Release Note for N412

Yeastar Information Technology Co. Ltd.

#### FIRMWARE VERSION 45.15.0.3

#### 1. Added support for switching Follow Me status using feature codes.

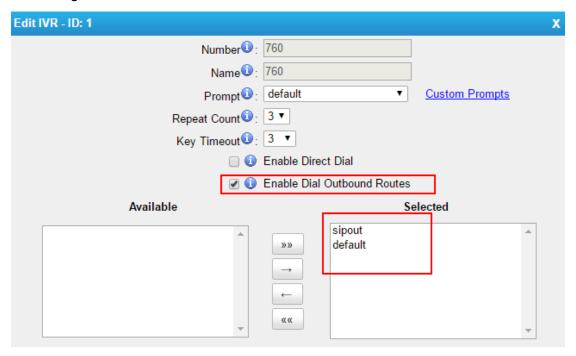
**Instruction:** dial the feature codes on your phone directly to switch the follow me status.

- Dial \*71 to forward all calls to voicemail; dial \*71500 to forward all calls to number 500; dial \*071 to disable forwarding of all calls.
- Dial \*72 to forward calls to voicemail when busy; dial \*71500 to forward calls to number 500 when busy; dial \*072 to disable when busy call forwarding.
- Dial \*73 to forward calls to voicemail when no answer; dial \*73500 to forward calls to number 500 when no answer; dial \*073 to disable no answer call forwarding.

#### 3. Added support for customization of ring tones.

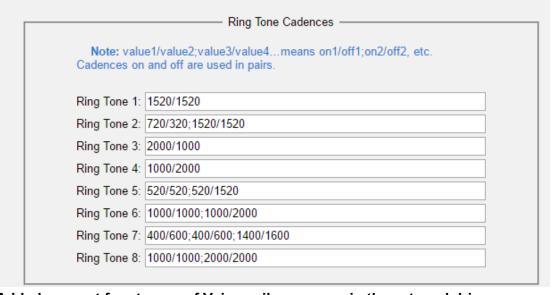
Instruction: Customize the ring tone cadences then click "Save" and "Apply".

### 14. Added support for canceling attended transfer when the called person does not answer.

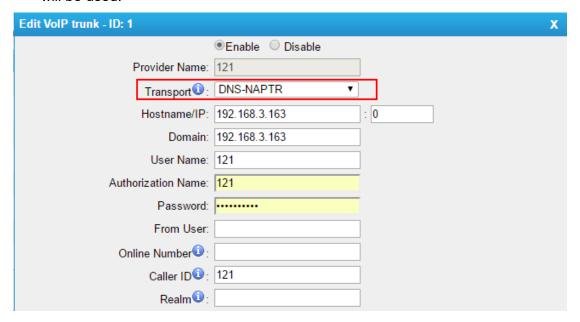
**Instruction:** if you make an attended transfer but the called person does not answer the call, you can dial the attended transfer feature code (\*3) again to retrieve the call.

#### 16. Added SIP related settings.

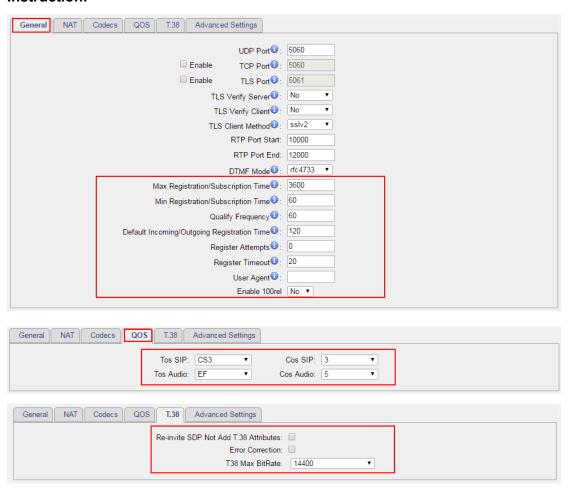
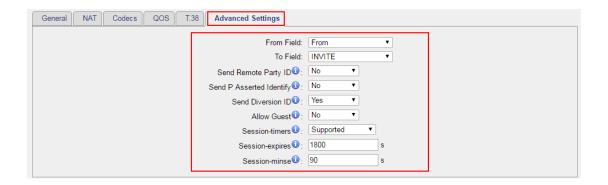
**Path**: PBX > Advanced Settings > SIP Settings **Instruction**:
